PERSHING AVE. FR. S.L. KELLOGG TO N.L. ORME, C&G E.S.

Paving Plan
Pershing Ave.
S.L. Kellogg
to
N.L. Orme
1290

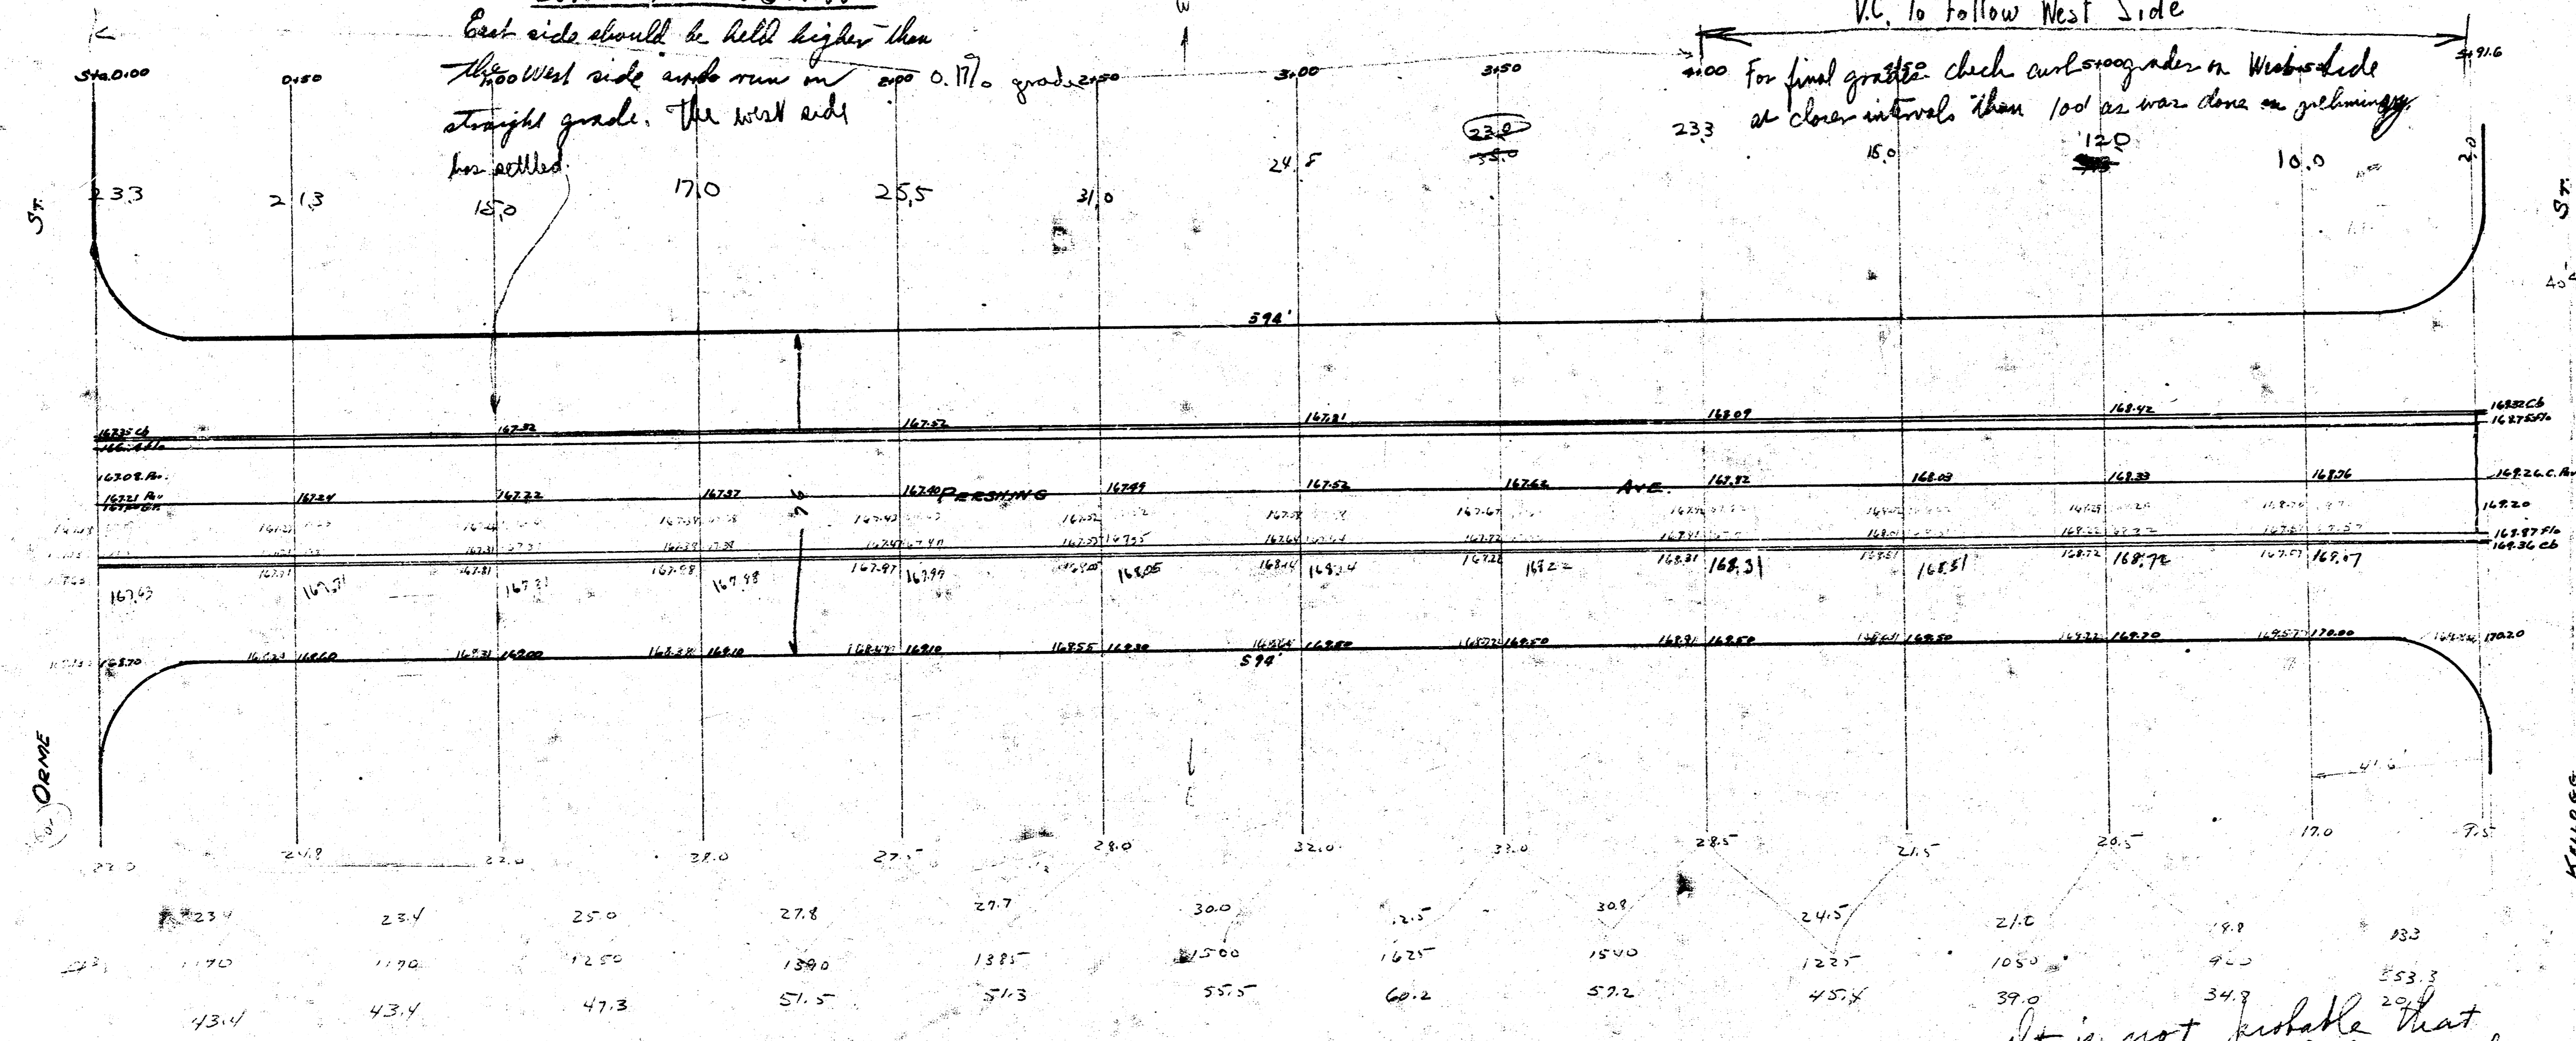
East side should be held higher than
the west side and run on
straight grade. The west side
has settled.

VC To Follow West Side

For final grades check curb grades on West side
at closer intervals than 100' as was done on preliminary

It is not probable that
excavation will be made
more than 5' from the gutter
into the street. Present street
surface being well established.
